SPERRY MARINE UK
Service Bulletin No. 41

Product: Decca BridgeMaster E Series Radars

Subject: Processor Electronics Unit

Processor Electronics Unit

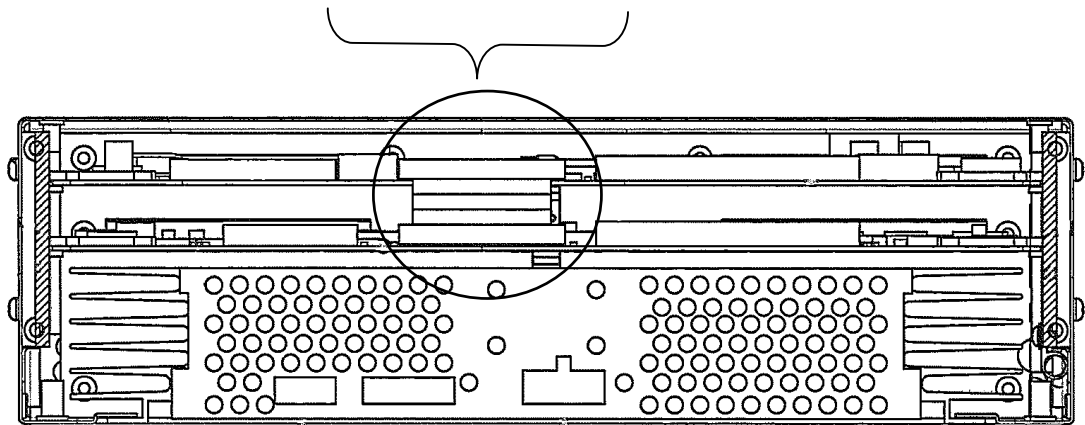
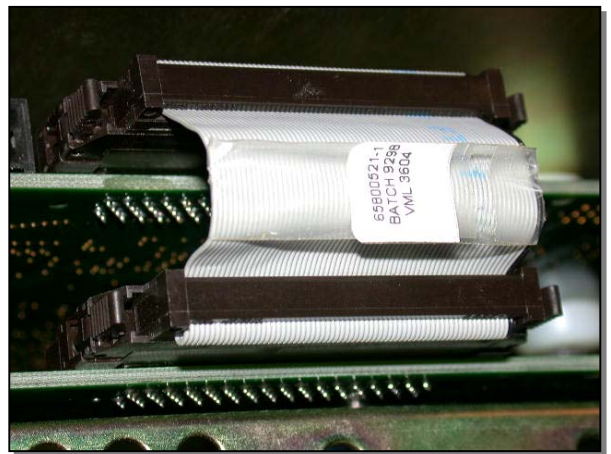
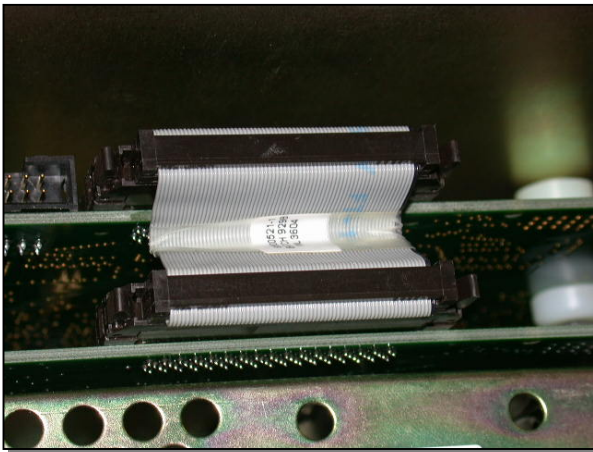
When replacing either the Display Processor PCB or the Radar Processor PCB ensure the ribbon cable (65800521) is bent INWARDS and check that the PCBs remain parallel to each other. This will prevent the possibility of the lower PCB being bowed by the cable and thus stopping it shorting on the Power Supply cover.
